SUBJECT: AMENDMENT NO. 192 TO FACILITY OPERATING LICENSE NO. NPF-3 -  
 DAVIS-BESSE NUCLEAR POWER STATION, UNIT NO. 1 (TAC NO. M84541)

Amendment No. 192  
License No. NPF-3

SAFETY EVALUATION BY THE OFFICE OF NUCLEAR REACTOR REGULATION  
RELATED TO AMENDMENT NO. 192 TO FACILITY OPERATING LICENSE NO. NPF-3

Figure 3.4-5  
Maximum Allowable Steam Generator Level  
in MODES 1 and 2

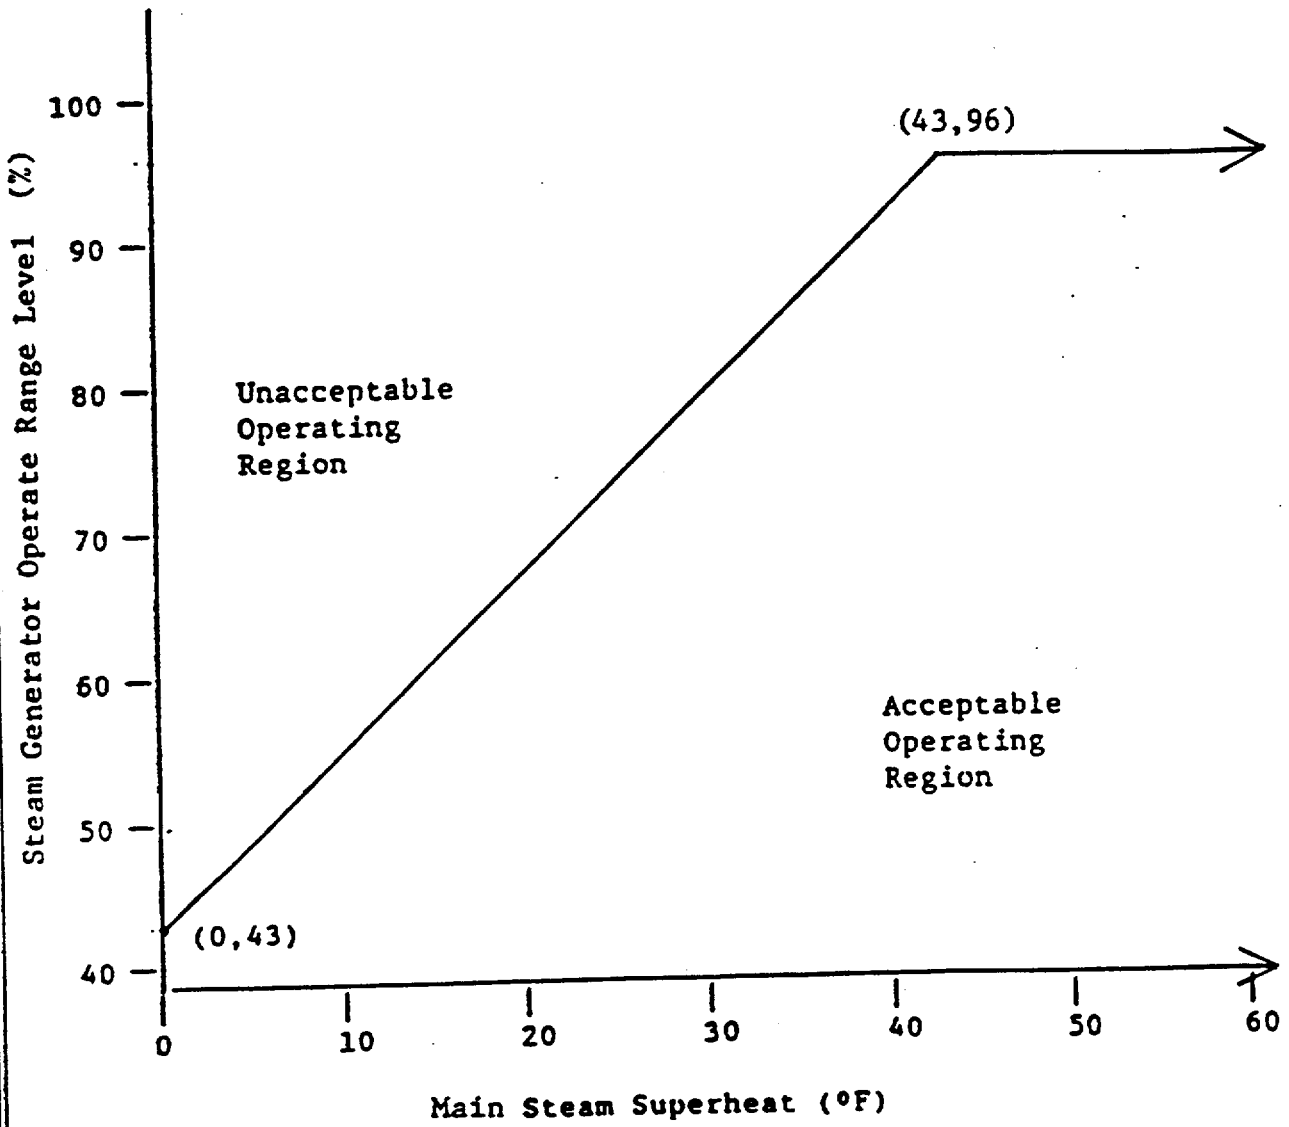
The proposed change to the TS 3.4.5 Limiting Condition for Operation (LCO) would modify the maximum allowable steam generator water level in Modes 1, 2, 3, and 4. The current LCO specifies a maximum water level of 348 inches for these modes of operation. The proposed changes would establish the following limitations for steam generator water level.

During MODES 1 and 2, both the acceptable and unacceptable operating regions for steam generator level are shown on Figure 3.4-5 (new). This figure presents the maximum Steam Generator level on the Operate Range level instrumentation expressed in percent as a function of Main Steam Superheat in °F.

- a. The acceptable operating region of Figure 3.4-5.
